# **3M's Comments on North Island Grid Upgrade Project Amended Proposal**

## **Application for Approval**

November 22, 2006

### **3M™ Aluminum Conductor Composite Reinforced (ACCR)**

Figure 1

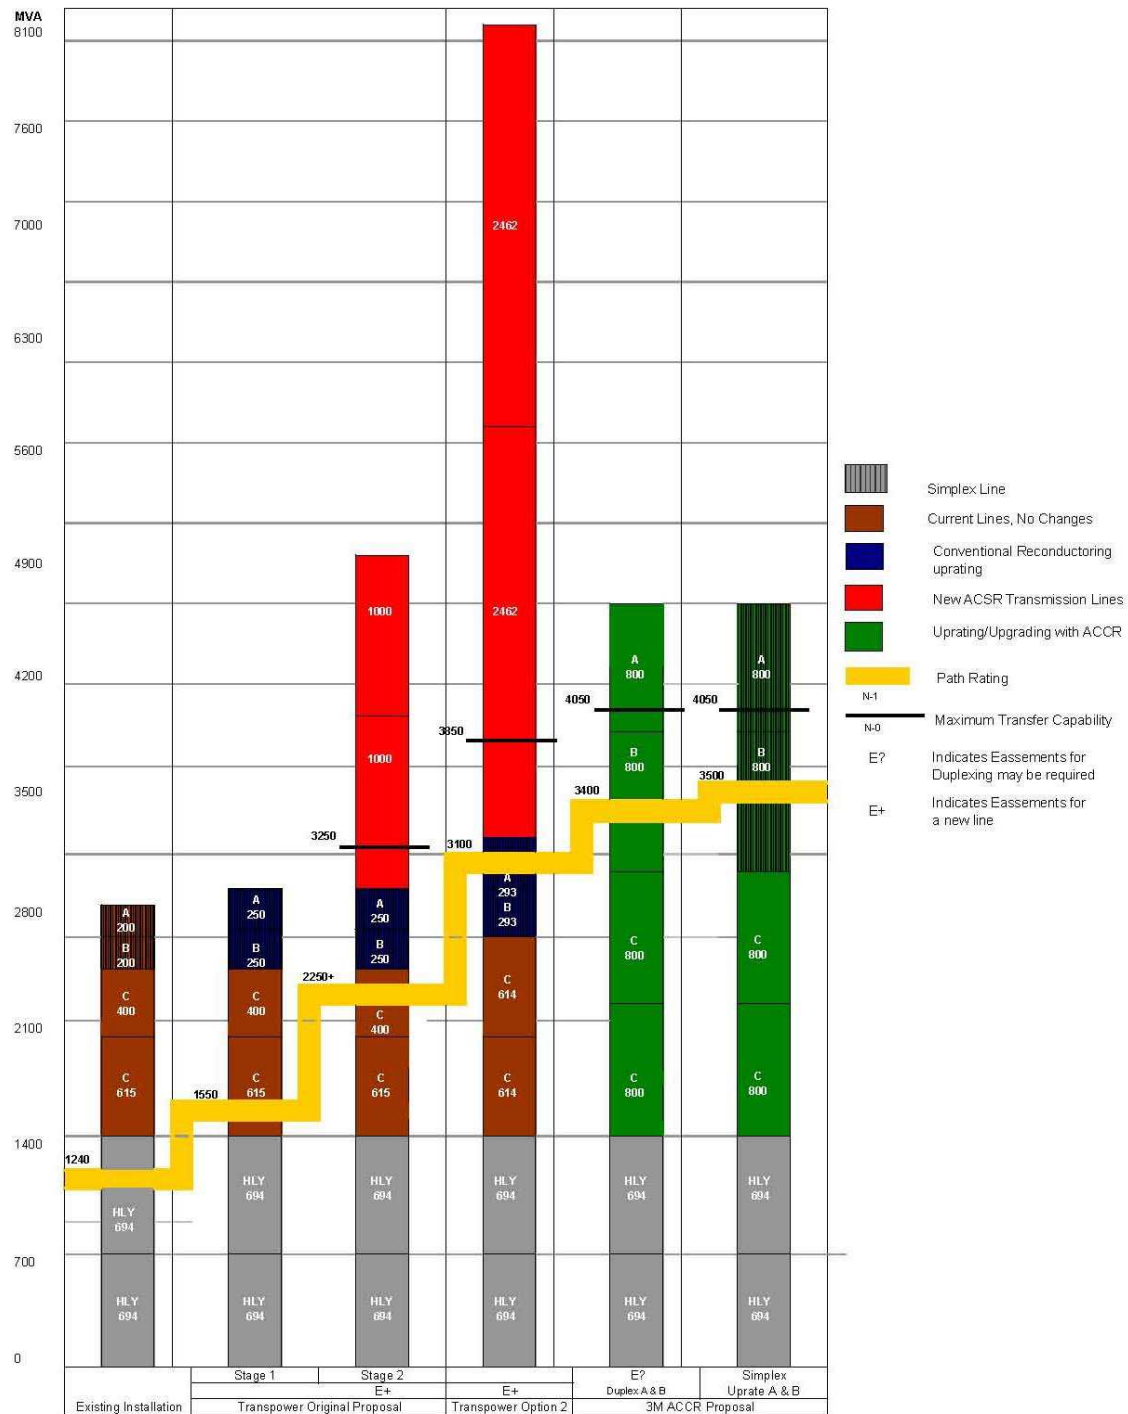
Figure 1 summarizes three example scenarios for increasing the capacity of the Auckland system to similar levels, based on a simplified power flow analysis<sup>1</sup>.

The first scenario is Transpower's original proposal and includes building a double circuit 400 kV line, resulting in 2,250 MVA.

The second scenario is Transpower's preferred option, Option 2<sup>2</sup>, and includes:

- constructing two new 2,462 MVA 400 kV transmission lines,

- providing 55% series compensation for the two new lines,
- installing twelve new 220/400 kV transformers,
- constructing a new receiving station at Ormiston Road,
- installing four new 220 kV cables connecting Ormiston Road with Otahuhu and Pakuranga substations, and
- installing 20 ohm series reactors in the Otahuhu-Whakamaru A & B lines to limit power flows over these lines.

Transpower's analysis of this scenario shows about 3,100 MW of capacity to the Upper North Island under the N-1 contingency limit in the year 2033, when the two new 400 kV lines are converted to 400 kV service. The result is a significant economic investment for no more gain than the competing options.

The next scenario is based on 3M's Scenario 1 from the original proposal, but uses smaller diameter ACCR than originally proposed. This options includes:

- providing 25% series compensation,
- looping the A&B lines into the new Huntly East substation,
- installing duplexed 300 kcmil Ostrich 3M ACCR conductor (600 MVA) between Whakamaru and Huntly East, and
- installing duplexed 477 kcmil Hawk 3M ACCR conductor (800 MVA) in all four lines between Huntly East and Otahuhu.

This could result in an Upper North Island transmission delivery capacity from the south of 3,400 MVA based on the N-1 contingency limit for the year 2033<sup>3</sup>. In this scenario, the use of smaller conductor than was assumed by Transpower will minimize the amount of tower modifications needed to accommodate the bundled high capacity 3M ACCR conductor. The 300 kcmil ACCR conductor is less than half the weight and cross-section of the Goat conductor assumed in Transpower's HTC option, while providing adequate capacity to support the Upper North Island.

If the choice were to install simplex conductor, the last scenario on the graph, and again assuming 25% series compensation, reconductoring the Whakamaru to Huntly East segments of the A and B lines with 795 kcmil Drake ACCR conductor (600 MVA), and the four Huntly East to Otahuhu lines with 1,272 kcmil Pheasant ACCR conductor (800 MVA), the resulting Upper North Island transmission delivery capacity (from the south) could be 3,500 MW's based on the N-1 contingency limit for the year 2033.

Both of the 3M ACCR options provide essentially the same N-1 transfer capacity to the Upper North Island while using smaller conductors than were studied by Transpower in its assessment of the viability of using HTC. An unbiased detailed assessment of the use of 3M ACCR could identify additional options that would provide even greater transmission grid transfer capacities by optimizing the conductor and series compensation characteristics. These two options, plus the two options identified in 3M's original proposal, are examples only, but are indicative of the results that could be achieved by optimizing the line design using 3M ACCR.
